8XC196KB AUTOMOTIVE APPLICATION SPECIFICATION UPDATE

Release Date: November, 1996

Order Number: 272970-001

The 8XC196KB may contain design defects or errors known as errata. Characterized errata that may cause the 8XC196KB's behavior to deviate from published specifications are documented in this specification update.

Figure 1. Quasi-bidirectional Port Circuit

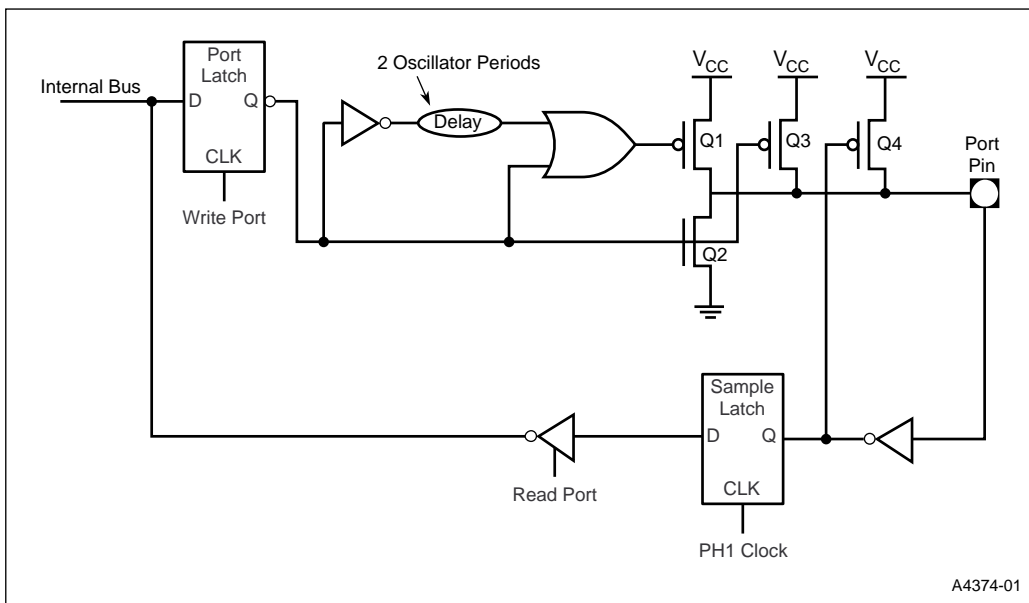
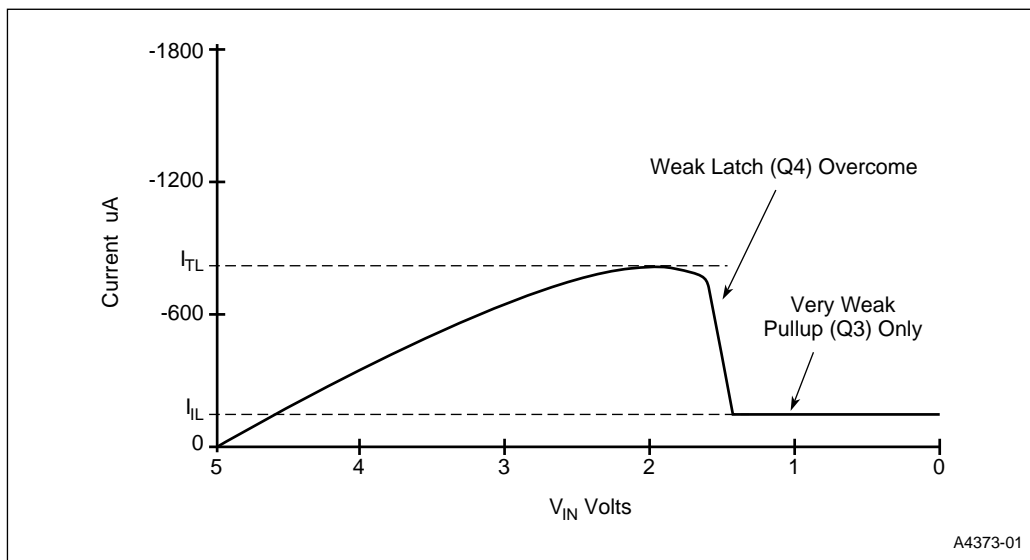
001. I_{TL} Specification Changed to $-800 \mu A$ (from $-650 \mu A$)

PROBLEM: The specification for I_{TL} on the 8XC198 and 8XC196KB/8XC196KB16 devices has changed from $-650 \mu A$ to $-800 \mu A$ to meet the device characteristics at low temperatures.

The I_{TL} specification is the maximum current that the 8XC196KB quasi-bidirectional pins can source during the transition from a logic 1 to a logic 0 input. Figure 1 shows the quasi-bidirectional port circuit. When the port is configured as an input, the output of the port latch is a '0'. Therefore, Q3 is weakly pulling the port pin high. When the external circuitry drives the pin high, Q4 also is turned on and holds the port pin signal high. As the external circuitry decreases the voltage below V_{CC} toward logic 0, Q4 begins to turn off. However, due to transistor characteristics, Q4 will source increasing amounts of current until the threshold voltage of the transistor is reached. Then, Q4 will turn off, leaving only Q3 driving the port pin signal high.

Figure 2 shows the transfer characteristic of the port pin during the input's transition from logic 1 to logic 0. The I_{IL} specification shows the amount of current Q3 will source after Q4 turns off. The I_{TL} specification gives the maximum amount of current that Q4 will source during the input's transition from logic 1 to logic 0.

IMPLICATION: Customers using the quasi-bidirectional pins as input should analyze their applications to see if their external circuitry can handle 80 μA of current from the quasi-bidirectional pins during the transition period described above.

Figure 3. Improved System Reset Circuit

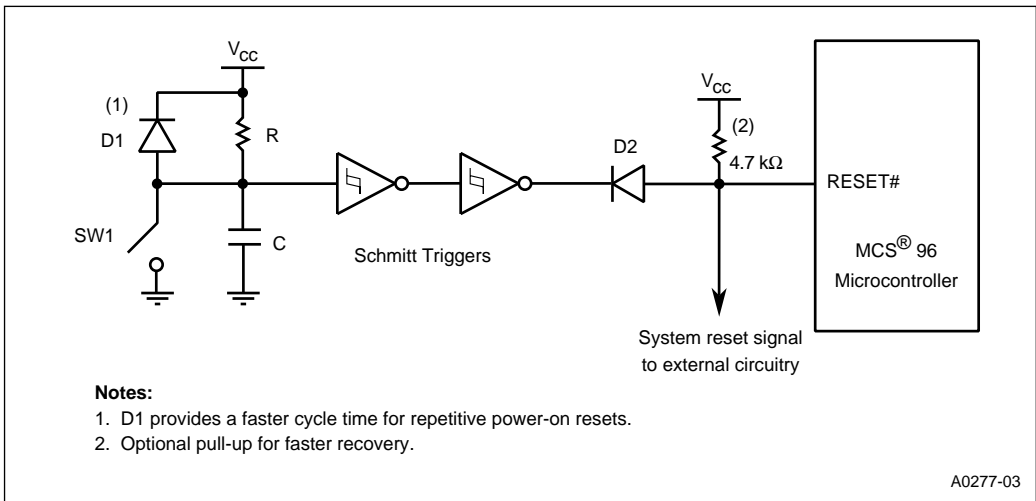
PROBLEM: The following improved system reset circuit shown in Figure 3 may be used in conjunction with the *80C196KB User's Guide* (270651-003).

The system reset circuit in the *80C196KB User's Guide* has been used successfully by many customers for a long period of time. Both circuits should be evaluated in the user's system.

The main difference between the two circuits is the addition of a 4.7 KΩ pull-up resistor. In some systems, the internal pull-up resistor on the RESET# pin is not sufficient, resulting in a slow rise time. Therefore, the external pull-up resistor was added to allow a more predictable rise time on the RESET# input. The external pull-up resistor is optional, but it may help ensure a clean reset, either for the 8XC196KB or for the external system.

The improved system reset circuit will be included in the next revision of the *80C196KB User's Guide*.
